Response

6.4.2 Climate Change

Figure 22
Thermal Coal Price Forecasts/Assumptions

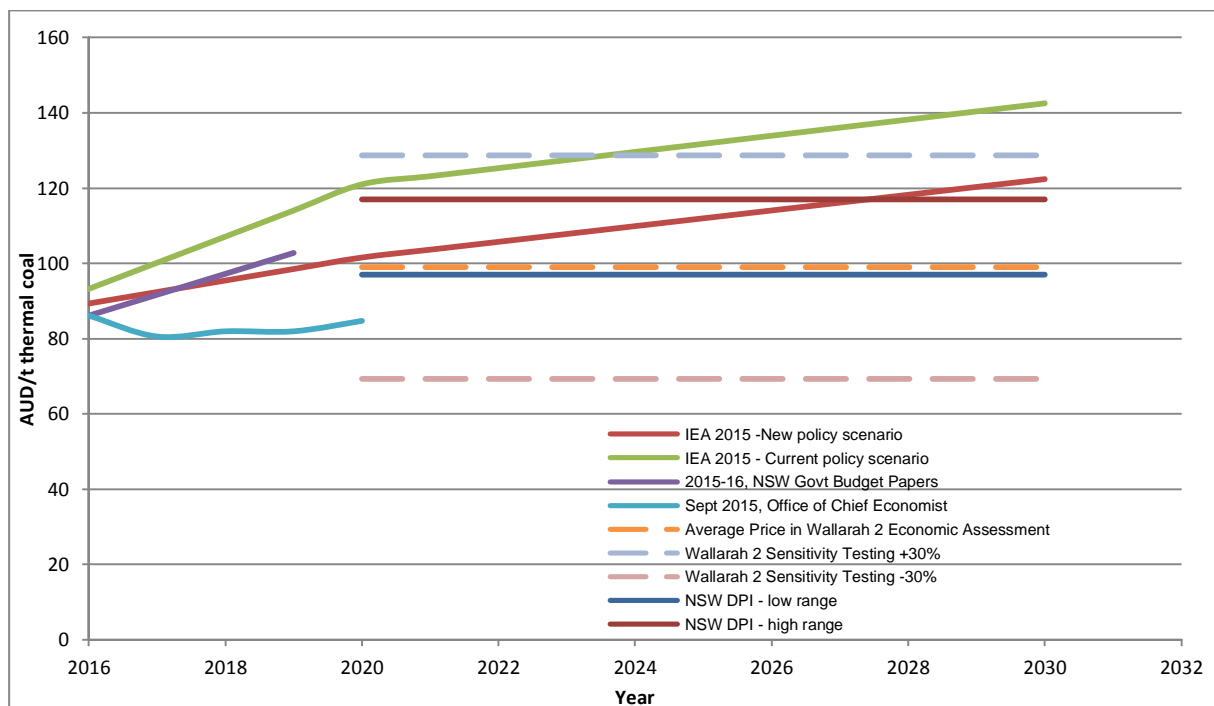
TAI refers to a 2014 Treasury Working Paper (Bullen et al, 2014) as an authoritative position on coal price forecast. However, the Commonwealth Treasury does not provide a long term coal price forecast in any of its budget papers and the views expressed in the referenced working paper were those of the authors not the Australian Government.

A comparison was provided of this forecast and a range of other forecasts and assumed coal prices. Refer to **Figure 22** (Figure 4.2 of the Economic Impact Assessment, Appendix J of the Amendment Document).

The Wood Mackenzie forecast coal prices used in this analysis are at the lower end of most coal price forecasts/assumptions. Nevertheless, it is recognised that there is uncertainty around future coal prices (valued in USD) as well as the USD/AUD exchange rate. Therefore, the assumed coal prices (in AUD) have been subjected to sensitivity testing for +/- 30% changes in AUD coal price as part of the Economic Impact Assessment (see Section 4.8, Appendix J of the Amendment Document). This encompasses even the most pessimistic price forecasts from the Office of the Chief Economist.

Figure 18: Pre-mining groundwater regime from Figure E17 of Appendix H of the EIS

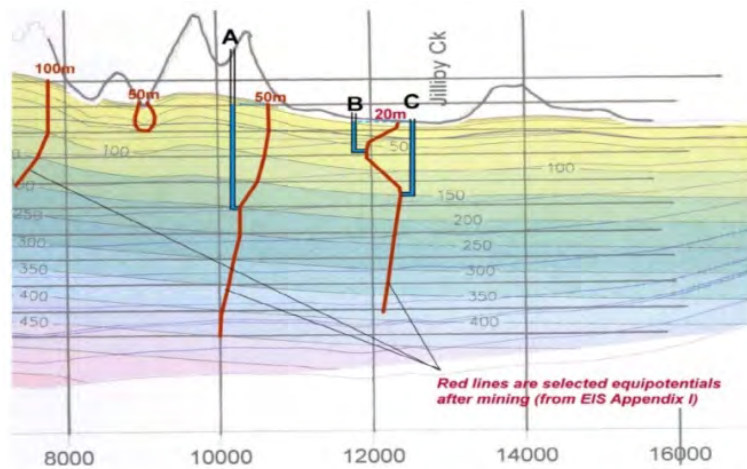
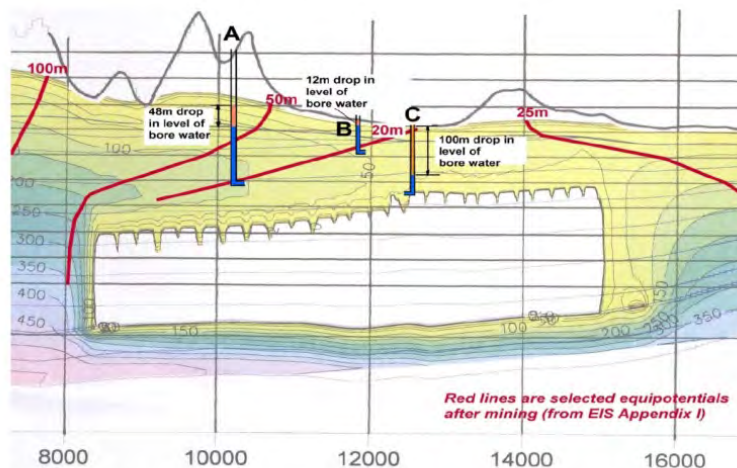
An issue related to the connectivity concept is given in Section 8.3.2 of the PSM report titled ‘Groundwater Impacts’ where Figures 18 and 19 (reproduced below) are used by PSM (2013) in their report to indicate in their view how the mining in the sub-surface (Figure 19) would affect hypothetical open ended bore water levels (actually piezometers as depicted in the figures by PSM rather than bores) compared to pre-mine conditions (Figure 18⁵). Figure 19 depicts the modelled pressure head section at Wallarah at full mine development and includes a MER modelled conservative assumption of complete drainage of the rock strata overlying the coal seam up to the constrained zone⁶ in Figure 19. PSM (2013) use this EIS MER model section of pressure heads to draw in the interpreted equipotentials (i.e. total head equal to pressure head plus elevation) to determine the water level in three hypothetical bores of different depth that are open at the bottom of each hole.

⁵ It is noted that while the Figure 18 title is for the pre-mining case the notation on that figure incorrectly states ‘after mining’ in the red notation regarding equipotentials, apparently mistakenly copied from Figure 19.

However, attention is drawn to the top of the saturated zone in both figures, that is, the watertable profile (top of the yellow shaded section) where it is clear that the position of the watertable is essentially the same in Figures 18 and 19. Consequently, this indicates that there is essentially no watertable drawdown created in the simulated modelled sections due to the sub-surface mining despite the implication by PSM and PC reports. That is, the pre-mine and end of mining watertable, is essentially unaffected by the deeper mining and the consequent modelled dewatering of the rock formation above the mined out seam in the section. Hence although the PSM report maintains that it has indirectly demonstrated mining influence at the surface by referring to these model section results, it is clear that Figures 18 and 19 on the contrary show no such drawdown influence. The depths adopted for the hypothetical bores/piezometers of course are imaginary and hypothetical and bear no relation to the depths of existing bores that currently lie within the mine footprint. In addition it is very unlikely that any bores constructed in this area, should they attempt to do so in the future, assuming no mining, would be drilled to the depths indicated, simply because of the limited groundwater potential and poor quality groundwater at these depths (see also Appendix herein Kalf (2010) review of PSM (2010) report item 6 paragraph 3 comment by

Figure 20 Vertical Permeability values from Appendix F of the EIS versus values used in groundwater impact assessment in Appendix G (After Figure 2.35 Valley Case)

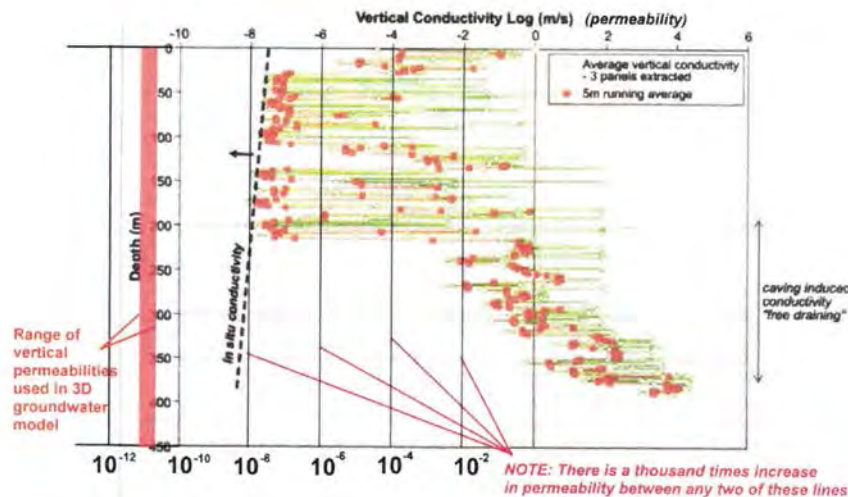
The PC report goes on to criticize the adoption of “*incorrect permeability data skewed to suit the Proponent*” in the Wallarah 2 numerical model. No further explanation is provided in PC report regarding this issue. However, the discussion in the PSM (2013) report Section 8.4.2.2 including Figure 20 is relevant. In this figure the PSM (2013) report makes a comparison between what they notate as the “*Range of vertical permeabilities used in 3D*

groundwater model” which they contend “are substantially on the low side of any realistic range of possibilities which have been identified in the EIS” and vertical fracture permeabilities generated by the SCT FLAC2D numerical fracture model also shown in the PSM (2013) Figure 20⁷.

⁷ The ‘NOTE:’ comment below Figure 20 that “There is a thousand times increase in permeability between any two lines” is incorrect. The graph x-axis depicts a factor of 100 not 1000 between lines.

The first point is that the FLAC2D permeabilities are fracture generated model values as opposed to bulk rock vertical permeability and are not measured. Secondly, Figure 20 used for the permeability comparison depicts depth from the ground surface to the assumed coal seam. The FLAC2D fracture permeabilities show firstly the presence a much higher fractured zone permeability zone at depth above the simulated goaf (those permeability values displaced to the right) and a zone higher in the profile (above about 200 m depth) representing the constrained zone of much lower permeability with the majority of values which lie along, or very close to a dotted line notated as “*insitu [vertical] conductivity*”. The “*insitu conductivity*” line is understood to have been estimated by the FLAC2D users and the small arrow pointing to left indicates a probable much lower value position of those insitu values. The red strip in Figure 20 drawn in by PSM, that is purported to represent the MER model permeability range, is therefore misleading since it is not related to total depth. On the contrary this permeability range only applies in upper constrained zone above a depth of about 200m from the ground surface.

With regard to [PSM (2013)] Figure 20, it is my understanding that the undisturbed permeability of strata above 200m is reflected in the concentration of data points at about $1E-08$ m/s ($8.6E-04$ m/day) down to about 200m depth. The dashed line and the arrow pointing to the left indicate that the insitu conductivity (permeability) could be anywhere to the left which includes the values employed in the groundwater model. The somewhat randomly higher values to the right of the dashed line may be associated with localised changes in lithology or localised presence of discrete and unconnected fractures. The reasoning behind the nomination of these values and the presentation of a 'running average' is best addressed by SCT.

There is also an important distinction between the two data sets. Very small cells are employed in the SCT model (1m x 1m in a 2 dimensional plane) while much larger cells (50m x 50m x 50m) are employed in the 3 dimensional groundwater model. It is inappropriate to associate the two models in the manner adopted by PSM on Figure 20".

Figure 1b

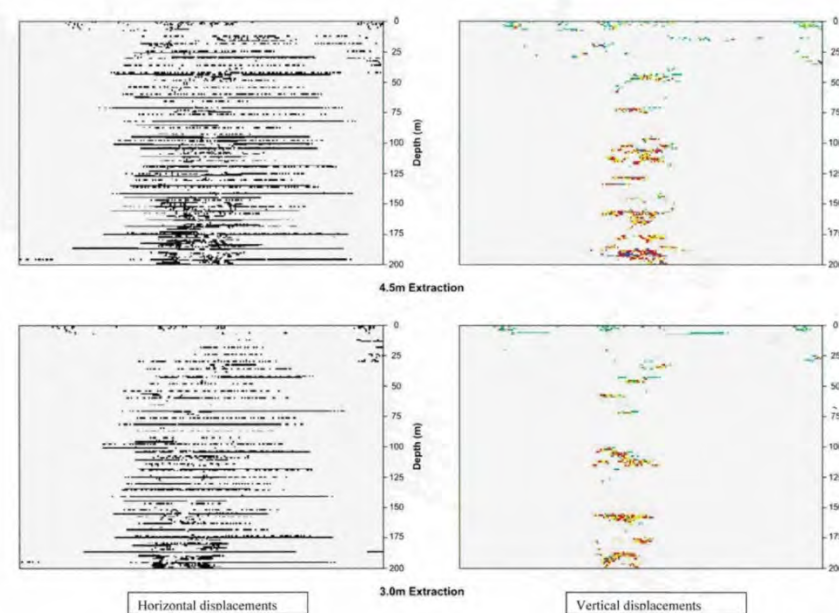
The PSM (2013) report states the assumptions regarding permeability in the MER 3D model are contradicted by calculations in the SCT/MSEC (Strata Control Technology and Mine Subsidence Engineering Consultants 2010) report. That is, PSM contend that there is some disruption of the strata throughout the 350m profile above the level of extraction. It overlooks that the SCT FLAC2D model predicts a dramatic reduction in vertical permeability above a depth of about 200m in their Figure 20 profile signifying the commencement of constrained zone conditions. The majority of this permeability change is primarily in the horizontal direction as is evident in the modelled fracture profile (reproduced in Figure 11 of PSM (2013) report below). The change in permeability is also evident in Figure 1b from MER

Figure 1b reveals a PSM (2013) report misunderstanding about their “*disruption*” comment that in the constrained zone while there is a significant increase in the horizontal permeability there is much less change, if any, in the vertical permeability.
